2024-06-18 #009

New SAV from 5th August 2024

RepNews created by

New SAV from 5th August 2024

New SAV Spring Comparison

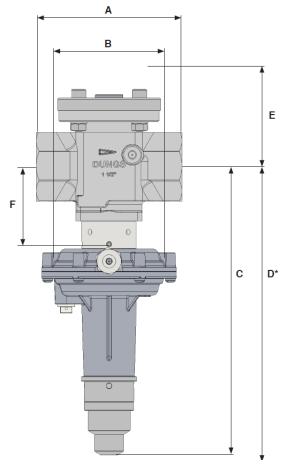
Specific	adjustment	range, underpressure W	fsu						
Spring	Order	Wire diameter	Length	Diameter	Setpo	oint range [mbar]			
colour	number	[mm]	[mm]	[mm]	ND	MD	UHD		
White	270353	1.2	60	10.0	10-32				
Yellow	270355	1.5	55	12.3	24-40				
Blue	270356	2.0	55	12.3	30-115	35-110			
Black	270357	2.3	55	12.3		50-250			
Purple	270358	2.5	55	12.3		80-400	150-500		
Orange	270359	2.8	55	12.3			300-1000		
Silver	270360	3.0	60	15.0			800-1400		
Pink	276126	3.5	60	15.0			1200-3000

Specific adju	Specific adjustment range, underpressure W _{dsu}												
Spring	Order	Wire	Lenght	Diameter	Setpoint ra	nge [mbar]							
colour	number	diameter	[mm]	[mm]	ND / MD	HD / UHD							
Yellow	303322	1,4	58,5	13	10 - 30	-							
Blue	303323	1,6	58,2	13	25 - 90	150 - 290							
Black	303324	1,8	58,3	13	70 - 160	250 - 560							
Purple	303325	2	58,3	13	140 - 310	520 - 1100							
Orange	303326	2,25	58,3	13	290 - 500	1050 - 1800							
Pink	303327	2,5	58,2	13	-	1650 - 3000

Spring	Order	range, overpressure W Wire diameter	Length	Diameter	Setpo	Setpoint range [r			
colour	number	[mm]	[mm]	[mm]	ND .	MD	UHD		
Silver	270361	2.2	60	30.0	40-130				
Green	270366	2.5	60	30.0	60-190				
Red	270367	2.7	60	30.0	90-240	180-290			
Yellow	270368	3.2	60	30.0		230-370			
Blue	270369	3.5	60	30.0		300-500	500-1000		
Black	270370	3.7	60	30.0		400-800	700-1300		
Purple	270371	4.0	60	30.0			1000-180		
Orange	270372	4.5	60	30.0			1300-250		
Pink	270373	4.8	60	30.0			1800-350		
White	271115	5.0	60	30.0			2500-500

Specific adju	Specific adjustment range, overpressure W _{dso}													
Spring	Order	Wire	Lenght	Diameter	Setpoint ra	nge [mbar]								
colour	number	diameter	[mm]	[mm]	ND / MD	HD / UHD								
Silver	303334	2,4	55,2	30	60 - 140	-								
Green	303335	2,8	55	30	80 - 220	-								
Red	303336	3,2	54,6	30	160 - 450	600 - 1700								
Yellow	303337	3,6	54,5	30	300 - 680	1250 - 2500								
Blue	303338	4	54,5	30	500 - 1000	1900 - 4500								
Black	303339	4,25	54,4	30	-	3500 - 5000

New SAV Dimensional comparison

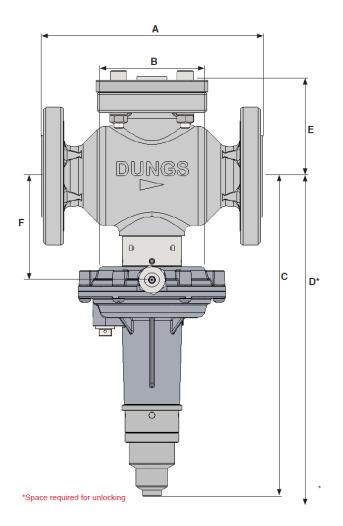
Туре	Order n	umber	p máx.	DN		Dimensions [mm]							Weight
	DIN	ANSI	[bar/kPa]		Α	В	С	D	E	F	G	Н	[kg]
SAV 100025 ND	270290	277797	10 / 1 000	25	184	120	240	490	83	78	12 x 1,5	G 1/4	7,6
SAV 100025 MD	270291	277799	10 / 1 000	25	184	120	237	487	83	78	12 x 1,5	G 1/4	7,6
SAV 250025 UHD	271122	275186	25 / 2 500	25	184	120	244	494	83	78	12 x 1,5	G 1/4	7,6
SAV 100040 ND	270293	277801	10 / 1 000	40	223	120	251	501	106	90	12 x 1,5	G 1/4	13,3
SAV 100040 MD	270294	277802	10 / 1 000	40	223	120	497	497	106	90	12 x 1,5	G 1/4	13,3
SAV 250040 UHD	271123	275184	25 / 2 500	40	223	120	255	505	106	90	12 x 1,5	G 1/4	13,3
SAV 100050 ND	270296	277804	10 / 1 000	50	254	120	260	510	116	99	12 x 1,5	G 1/4	16,0
SAV 100050 MD	270297	277805	10 / 1 000	50	254	120	256	506	116	99	12 x 1,5	G 1/4	16,0
SAV 250050 UHD	271124	273855	25 / 2 500	50	254	120	264	514	116	99	12 x 1,5	G 1/4	16,0

Bestelln	nummer	p max.		Einbaumaße [mm]							
Тур	DIN	ANSI	[bar/kPa]	DN	Α	В	С	D	E	F	G	Н
SAV 100025 ND-MD	270291	277799	10 / 1000	25	184	122	267	317	88	86,5	12	G 1/4
SAV 250025 HD-UHD	271122	275186	25 / 2500	25	184	122	267	317	88	86,5	12	G 1/4
SAV 100040 ND-MD	270294	277802	10 / 1000	40	223	122	273	323	104	96,5	12	G 1/4
SAV 250040 HD-UHD	271123	275184	25 / 2500	40	223	122	273	323	104	96,5	12	G 1/4
SAV 100050 ND-MD	270297	277805	10 / 1000	50	254	122	276	326	116	105	12	G 1/4
SAV 250050 HD-UHD	271124	273855	25 / 2500	50	254	122	276	326	116	105	12	G 1/4

- Same lengh
- Higher height (10-30mm bottom distance)
- Lower free distance below needed for Exchange ASE or springs
